Please find enclosed three partial sections of drawings 1E & 2E-300327, Remington receiver insert. Unfortunately the receiver insert CADD file has become corrupt, therefore the detailed drawings could not be updated per the alterations we discussed over the phone. Please accept the initialed sections as authority to proceed with tool alteration estimates. Upon receipt of the quotations, a P.O. will be issued for the alterations. The alterations must be completed prior to the next sampling of the tool. An updated drawing depicting the changes as marked will be supplied by 6/7/99. 83

The only change to 1E-300327 will be the increase of the 1.046 \pm .001 diameter band to 1.049 \pm .001. On 2E-300327, the three screw slots will require the following alterations; increasing the depth to .115 from C Datum and replacing the semi-circular bottom with a flat surface and .020 radii corners.

DWG - ZE-300327

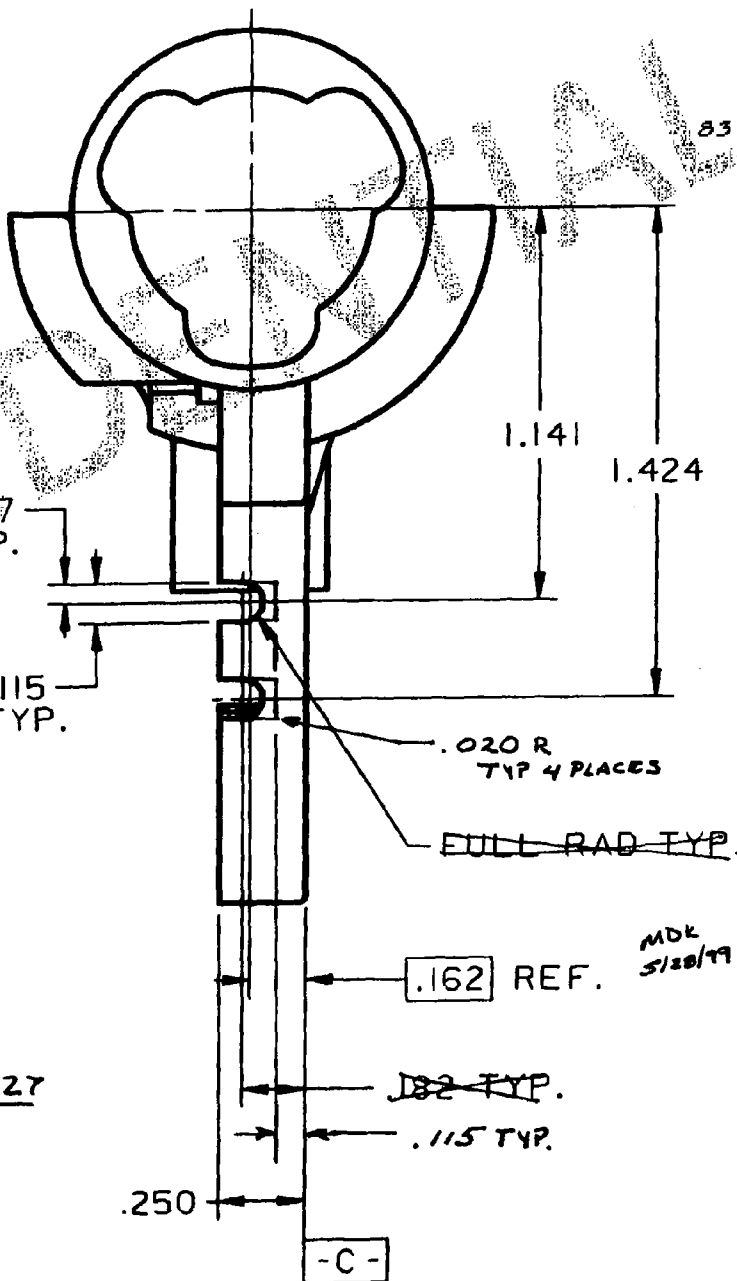
Per our phone conversation, please also review the .122 and .097 hole diameters as well as the .175 standoff heights. If your inspections indicate out of tolerance conditions, please perform tool corrections prior to the next sampling of the tool. Based on our schedule, dimensionally correct parts will be required by 6/21/99.
